IEEE P802.15
Wireless Personal Area Networks

Project	IEEE P802.15 Working Group for Wireless Personal Area Networks (WPANs)	
Title	TG3 LB19 comment resolution	
Date Submitted	[3 October, 2002]	
Source	[James P. K. Gilb] [Apparent Technologies] [9921 Carmel Mountain Rd. #247, San Diego, CA 92129]	Voice: [858-538-3903] Fax: [858-538-3903] E-mail: [gilb@ieee.org]
Re:	[]	
Abstract	[This document is a record of comment resolutions for LB19.]	
Purpose	[To provide a record of the comment resolution for LB19.]	
Notice	This document has been prepared to assist the IEEE P802.15. It is offered as a basis for discussion and is not binding on the contributing individual(s) or organization(s). The material in this document is subject to change in form and content after further study. The contributor(s) reserve(s) the right to add, amend or withdraw material contained herein.	
Release	The contributor acknowledges and accepts that this contribution becomes the property of IEEE and may be made publicly available by P802.15.

Figure 5—PNC handover MSC

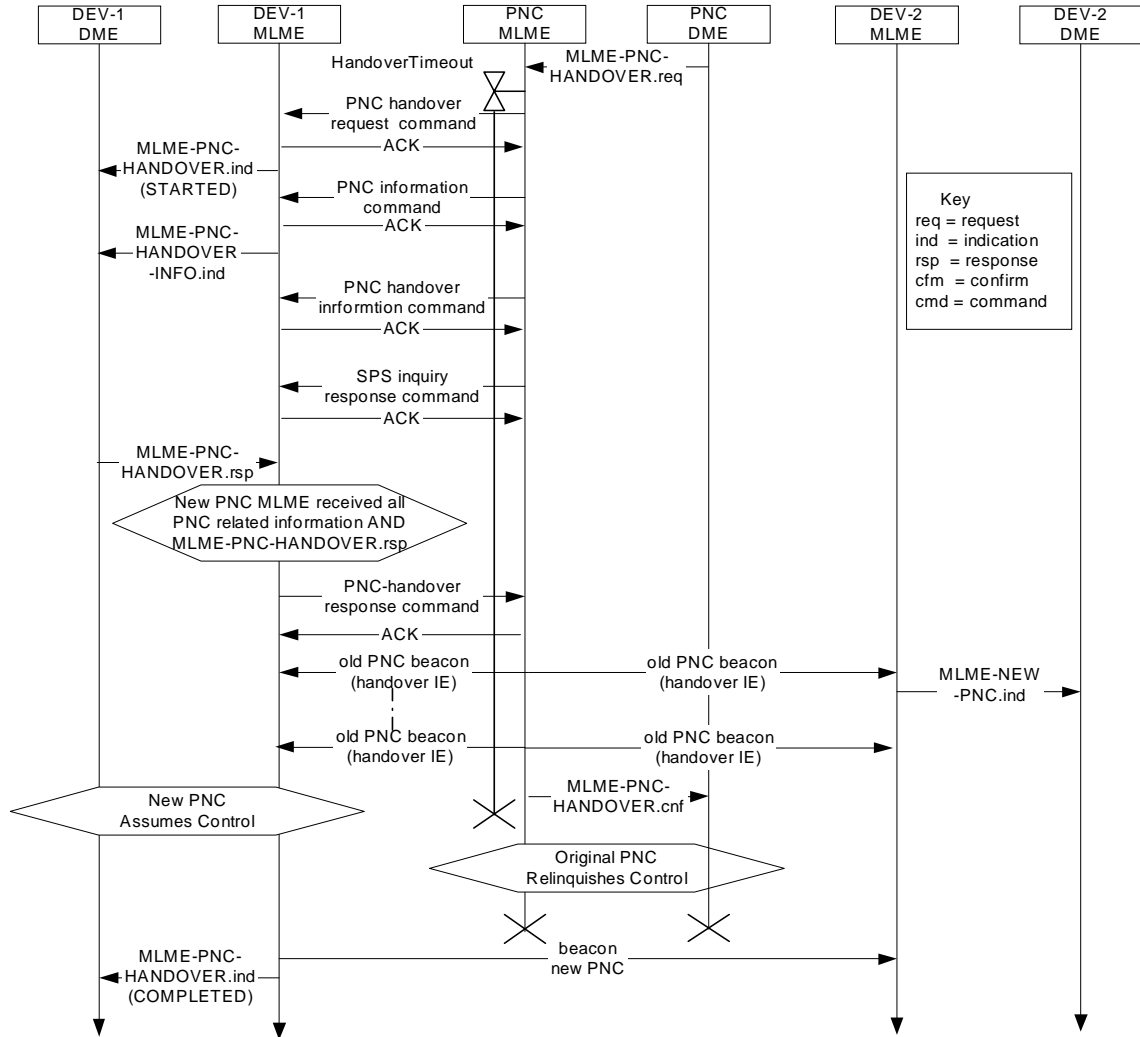
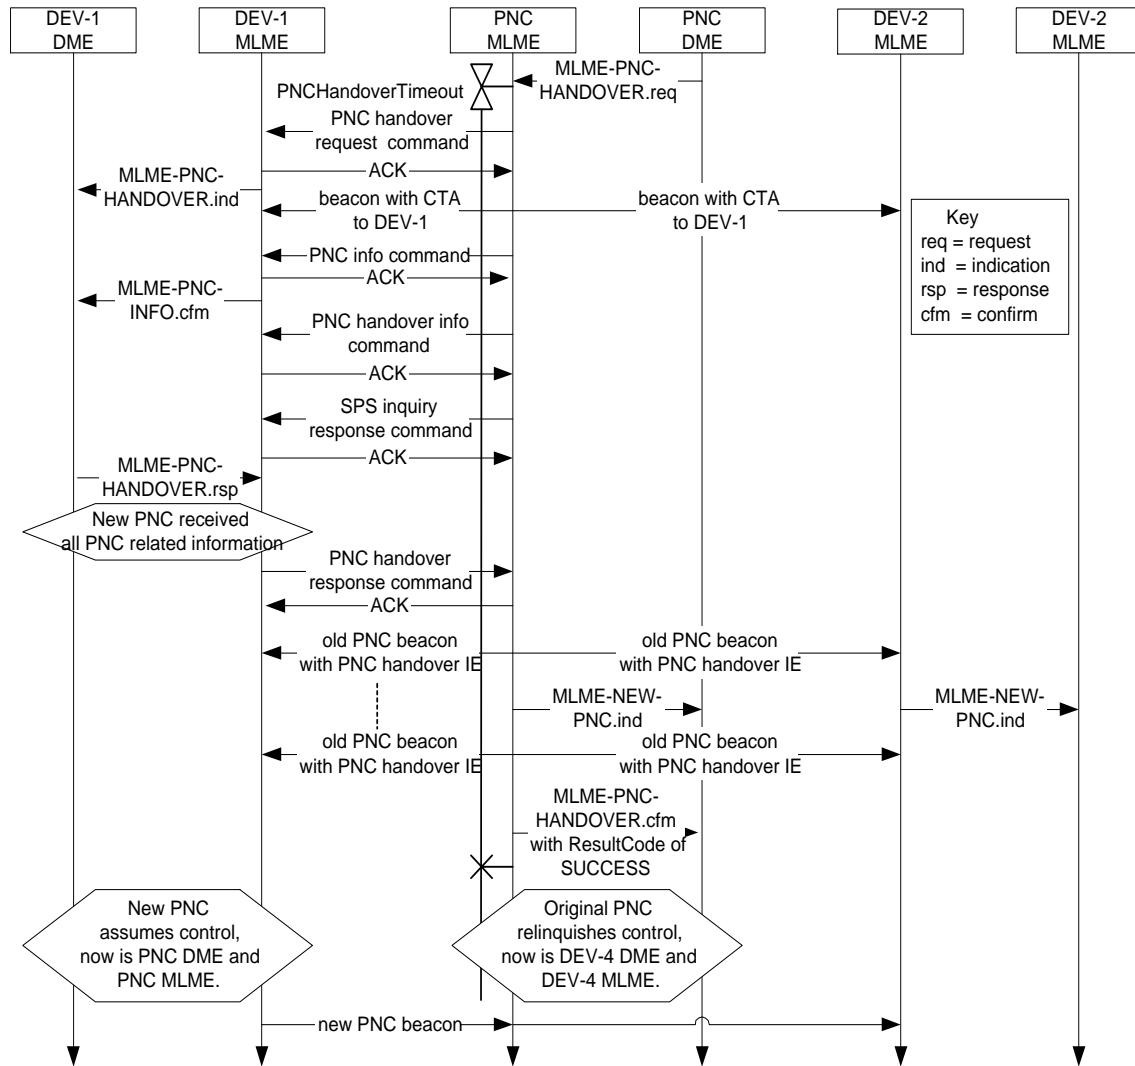
269 (Heberling, TR) - [PNCHndOvr] Some errors in text remain or were introduced after LB17.MSC in Figure 91 is also wrong./KO Text changes for 8.2.3 and ne MSC for Figure 91 are all collected in:02276r7P802-15_TG3-commentsD11_KO.doc, Resolution [03]. **Suggest accept in principle**, “The MSC will be modified as indicated in the resolutions of CID 58 and 232. Make the following text changes: In 6.3.13.4, page 59, line 45, change ‘This primitive informs the originating DME its request for information from the PNC is complete.’ to be ‘This primitive informs the DME that the MLME has received a PNC information command, {xref 7.5.4.2}.’ In 7.5.3.1, page 138, line 20 ‘the number of information records to be transferred using the PNC information command frame(s).’ to be ‘the number of DEV information records, {xref PNC handover info command}, that will be transferred from the old PNC to the new PNC.’ In 8.2.3 PNC Handover, delete page 156, line 8-9, redundant, same text in paragraph below. Add to page 156, line 19, ‘The PNC handover information command shall not be sent if the PNC has indicated in the PNC handover request command that it does not have any CTRBs to transfer.

Handover MSC - various comments, suggestion from 02276r7P802-15_TG3-commentsD11_KO.doc below (with some editorial work):

463 (Gubbi, TR) - Figure-91 is a well done job, but the text needs to supplement some info that can not be expressed in the figure, which is incomplete in the current update to this para. It should be mentioned that these commands shall be sent by PNC even if there is no information present that fits into those commands so that the rx-DEV knows the exact end of the transaction. For example, what if there are no DEVs in power save mode. Still the SPS-inquiry-response-command shall be sent by PNC. It should be mentioned that the three commands in Figure-91 (PNC-info-command, PNC-handover-info-command and SPS-inquiry-response-cmd) shall be sent by PNC even if there is no information present that fits into those commands so that the rx-DEV knows the exact end of the transaction. For example, what if there are no DEVs in power save mode. Still the SPS-inquiry-response-command shall be sent by PNC. **Suggest accept in principle.** "Rather than send the empty commands, the PNC handover request will contain the number of CTRBs and SPS sets that will be transferred. If the number of items is zero, then the old PNC shall not send the command and the new PNC will not expect to receive it. It is not possible for the number of DEVs to be less than 2 (i.e. the old PNC and the new PNC), so the PNC information command will always be sent. This is documented in the resolution of CID 269."

The SPS inquiry response command shall not be sent if the PNC has indicated in the PNC handover request command that it doesn’t have any SPS sets to transfer.’

Add to page 156, line 35, ‘The new PNC shall broadcast its first beacon at the time the beacon would have been sent by the old PNC. This time may vary from the actual time due to clock inaccuracies of old and new PNCs. The new PNC shall start sending beacons with the beacon number counter set to one more than the beacon number of the last beacon that will be sent by the old PNC.’

Add page 156, line 40ff, ‘The PNC shall ensure that the beacon countdown includes at least one system wake beacon and at least aMaxLostBeacons beacons following that system wake beacon. The only exception to this requirement is if the PNC will be shutting down and does not have enough time to to wait for the next system wake beacon to complete the handover process. {Ed. note: This line may be moved to a new 8.1.1 that describes all beacon announcements.’}
